# HILLTOP ACRES ESTATES

RE: SUB 2003-98 -- Final Plat of Hilltop Acres Addition

RE: SUB 2003-98 -- Final Plat of Hilltop Acres Estates Addition

**CASE NUMBER:** SUB 2003-98 -- HILLTOP ACRES ESTATES ADDITION

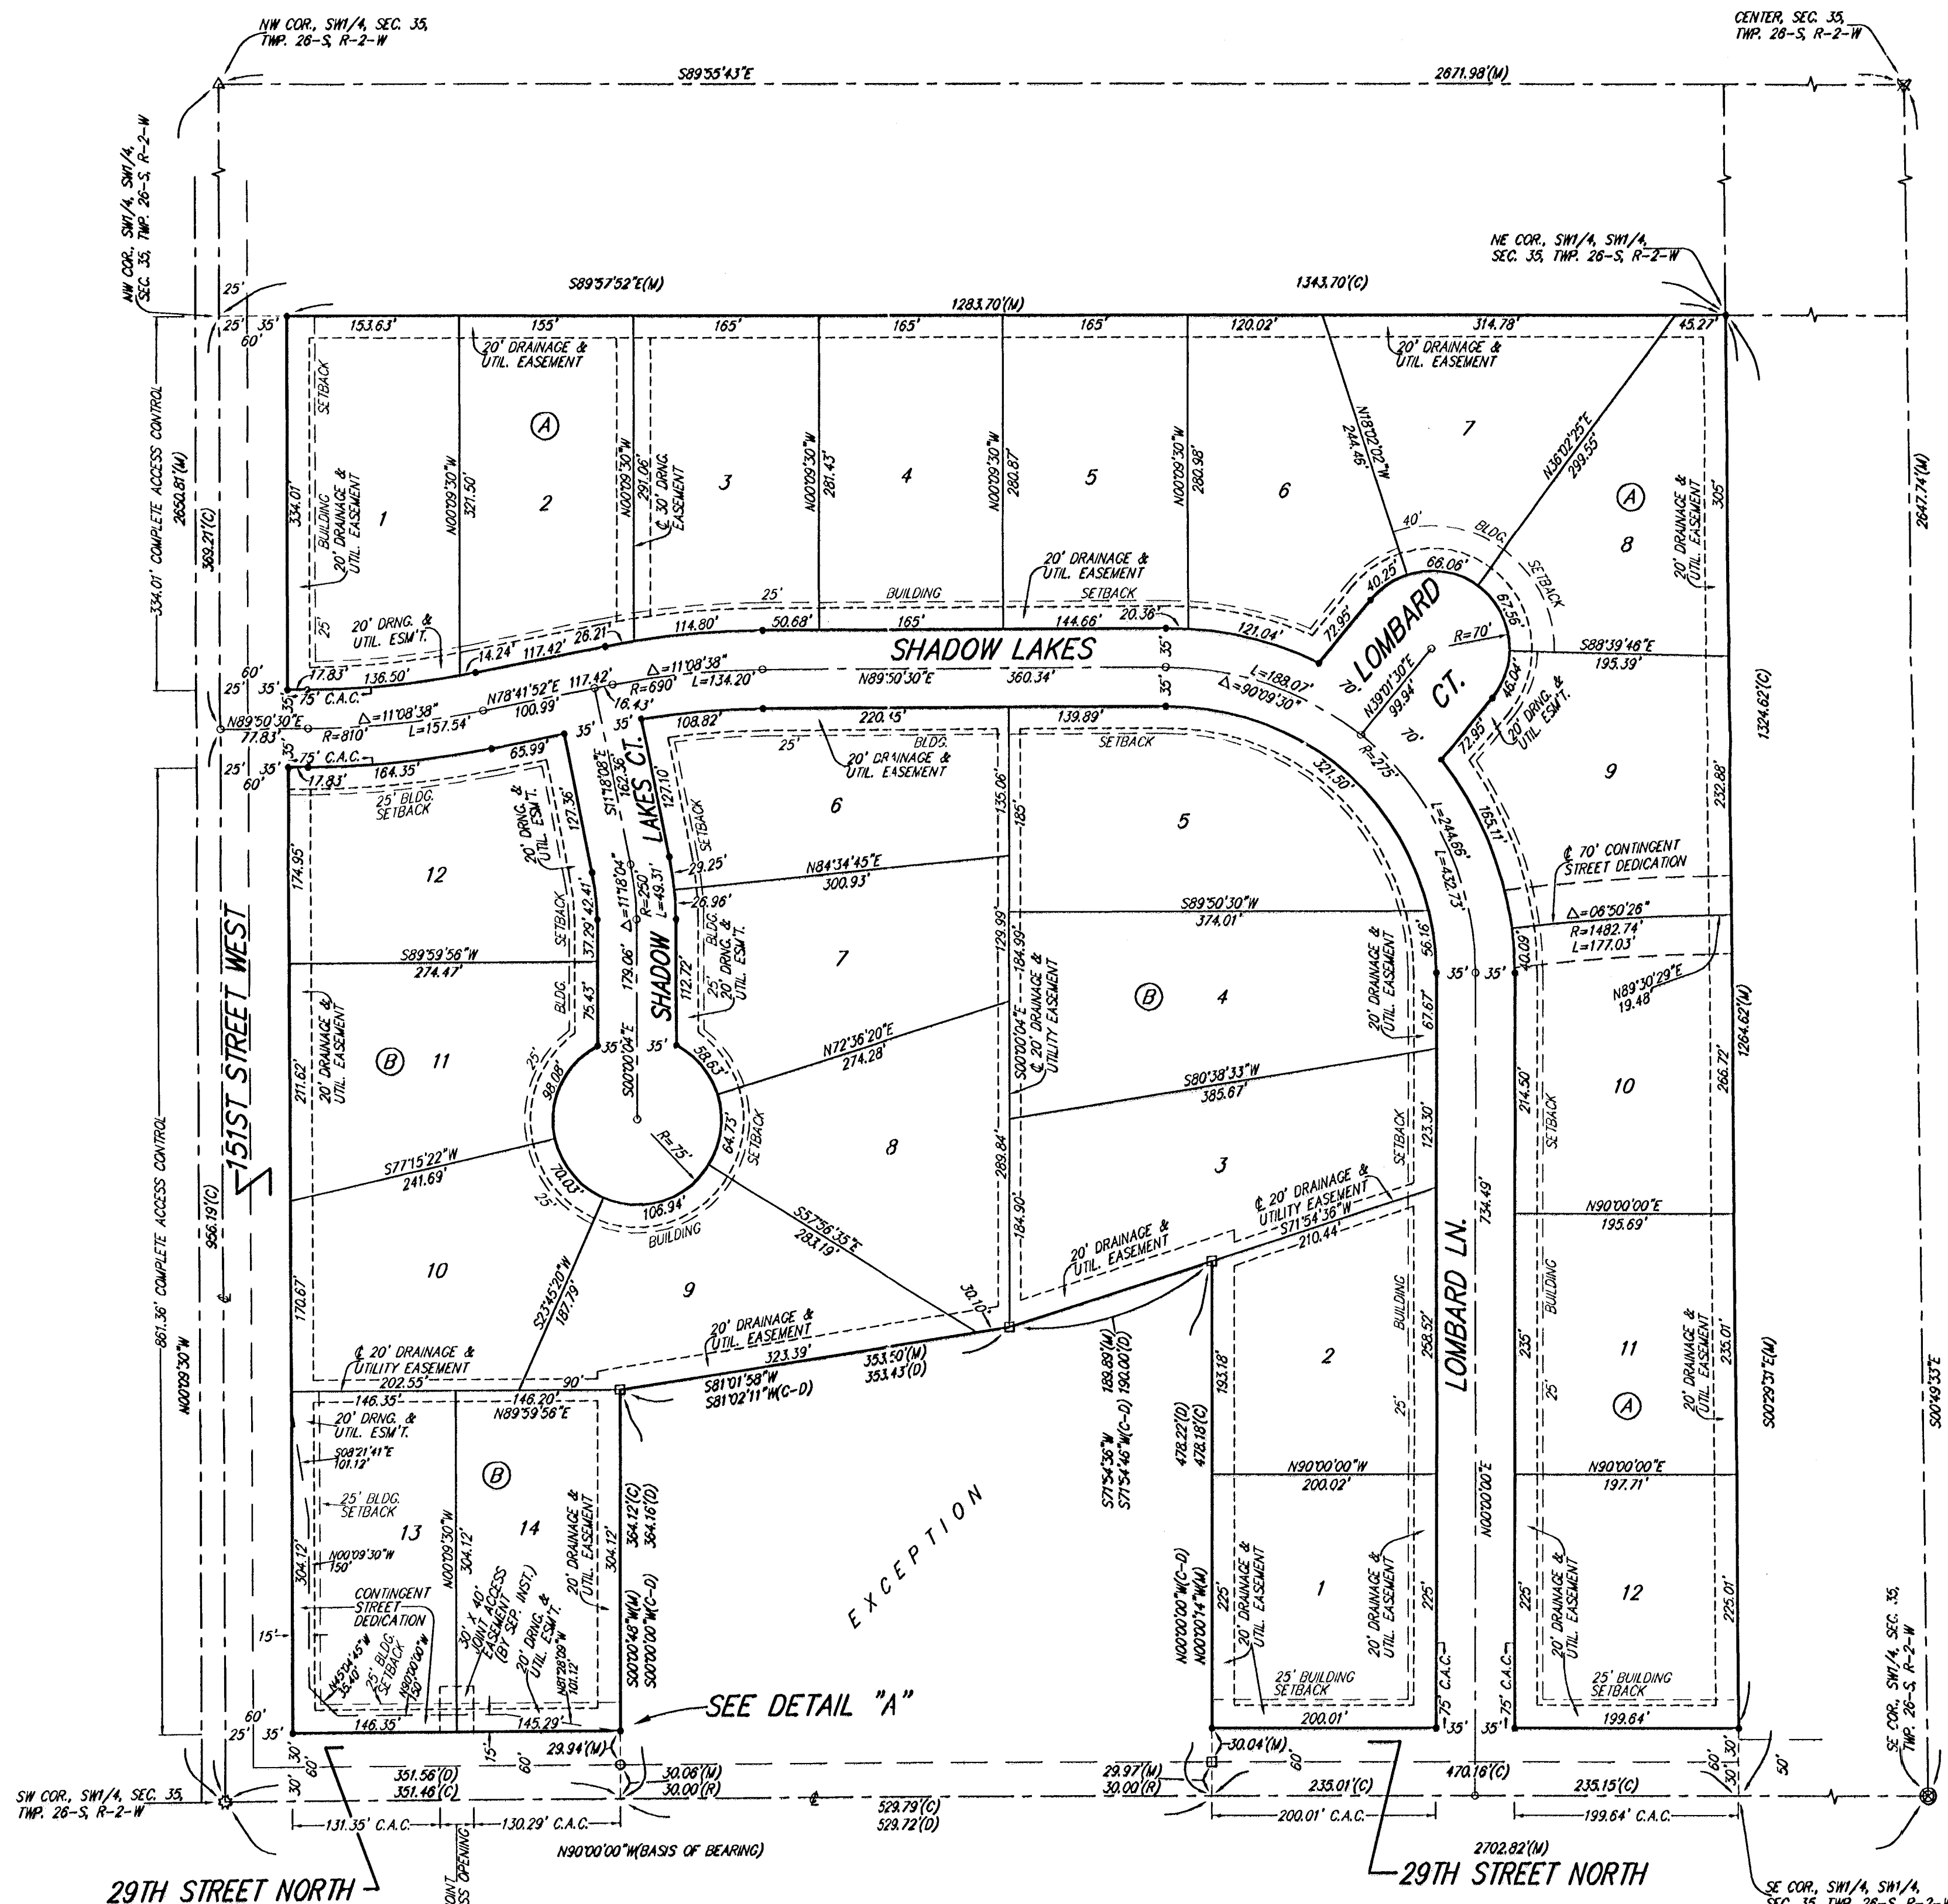
- G. A contingent street right-of-way has been platted for the required major intersection right-of-way and corner clip. The Subdivision Committee approved a contingent street right-of-way for the intersection.

- H. In accordance with Access Management Regulations for county plats, complete access control is required for arterials intersecting with local streets. County Engineering has requested complete access control of 75 feet along Hilltop from both 151st St. West and 29th St. North.

- J. The applicant shall guarantee the installation of Shadow Lakes Ct to the 36-ft rock suburban street standard.
- K. The Subdivision Committee has requested the platting of additional utility easements along the rear of the lots.

- M. Approval of this plat will require a waiver of the lot depth to width ratio of the Subdivision Regulations for Lots 3 and 4, Block B. The Subdivision Regulations state that the maximum depth of all residential lots shall not exceed 2.5 times the width. The Subdivision Committee has approved a modification.

- N. GIS needs to comment on the plat's street names. Lombard Lane Circle shall be revised to Lombard Ct. Lombard Lane should be denoted as "Lombard Ln".

- P. The platlor's text shall include language that a drainage plan has been developed for the plat and that all drainage easements, rights-of-way, or reserves shall remain at established grades or as modified with the approval of the applicable City or County Engineer, and unobstructed to allow for the conveyance of stormwater.

NOTE:  
A master grading plan for drainage has been developed for this subdivision and is on file with the appropriate governing body. All drainage easements, rights-of-way, or reserves shall remain at established grades or as modified with the approval of the Engineer for the appropriate governing body. No obstructions which impede the flow of this drainage system shall be allowed.

This contingent street dedication shall be referenced in the plat's text as becoming effective in the event that the appropriate governing body determines a need for the right-of-way for any street-related purposes.

The requested access controls have been platted.

The easements have been platted as requested.
